# Basic Plan Review

## 14-002BPR/CU – BSC Office District

### State Bank – West Dublin-Granville Road and Shamrock Boulevard

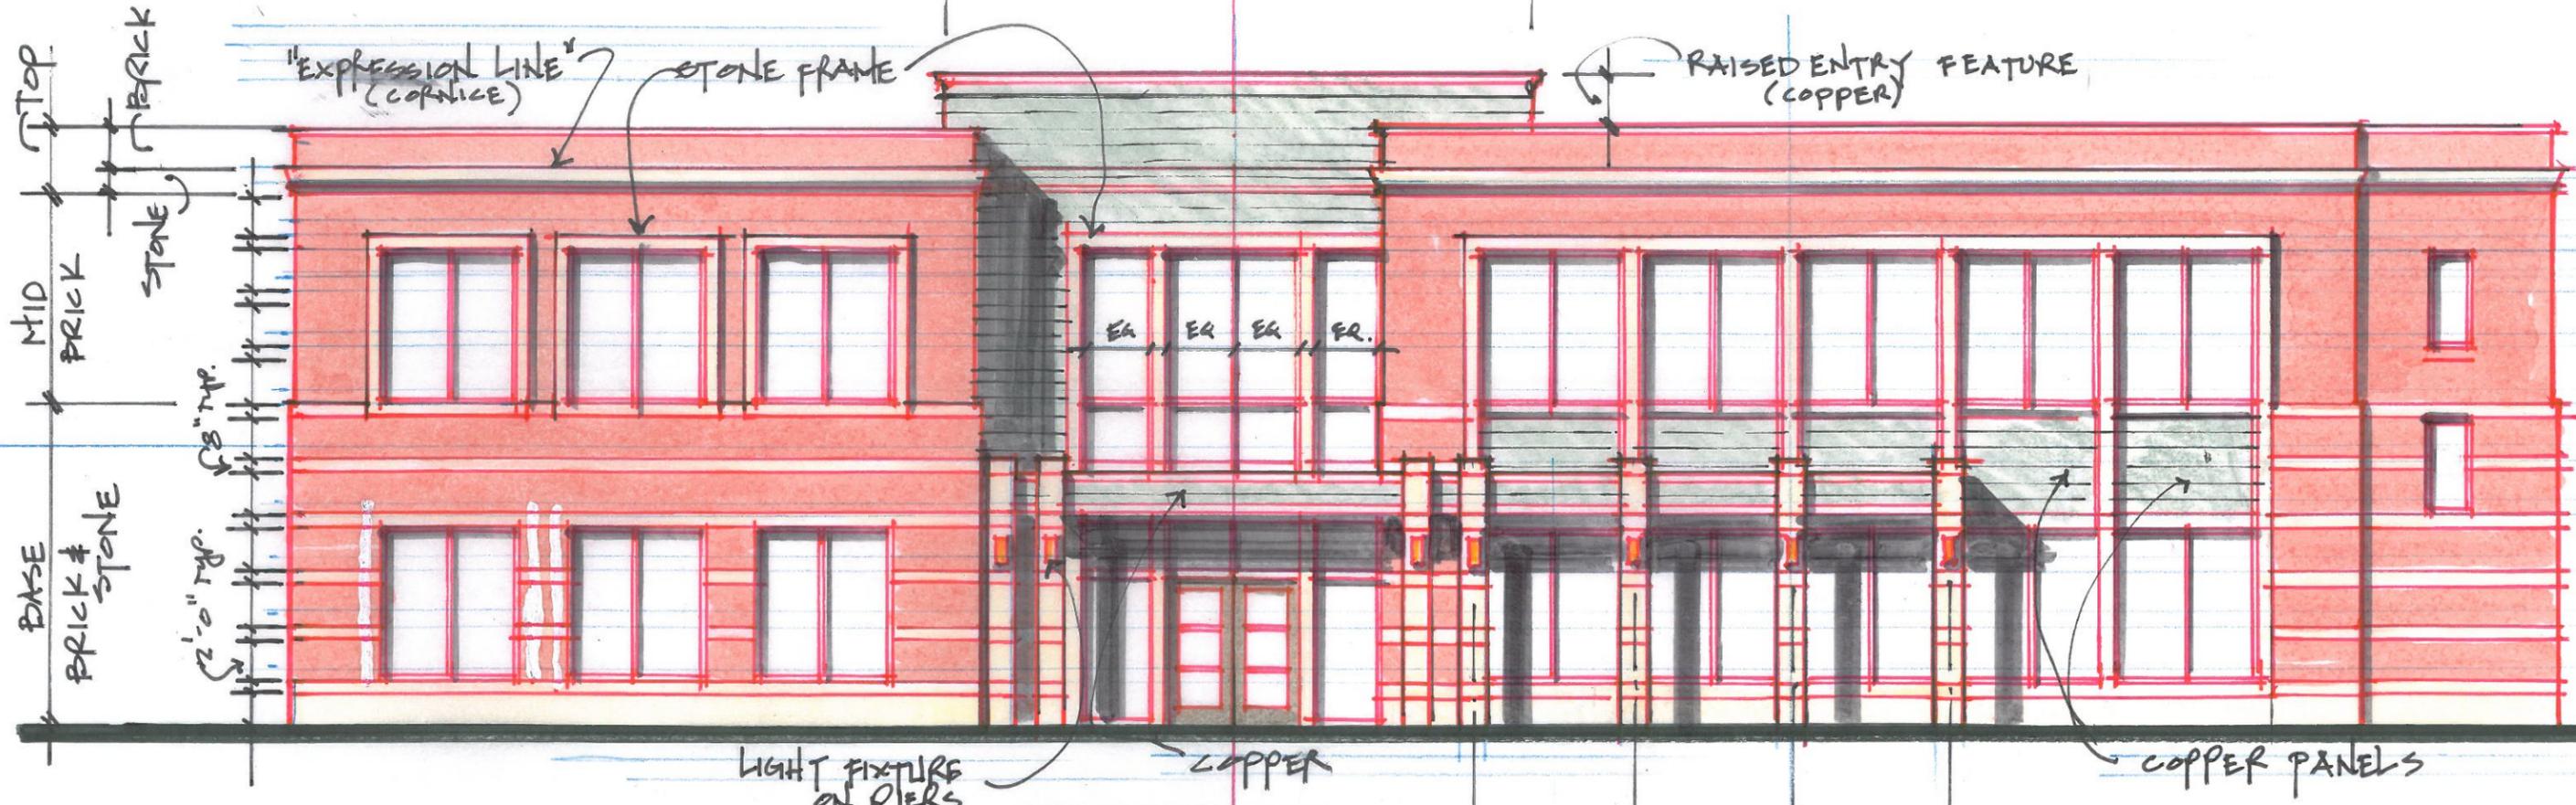
- a. There is no “expression line” along the parapet
- b. An additional entry door needs to be added on the street side.

4. The uniform stoned-framed windows forming the large bays are foreign to the non-articulated random-sized punched windows
- b. Incorporation of stone bandings or brick bandings could be added into the main building (maybe to form a base) would help the integration
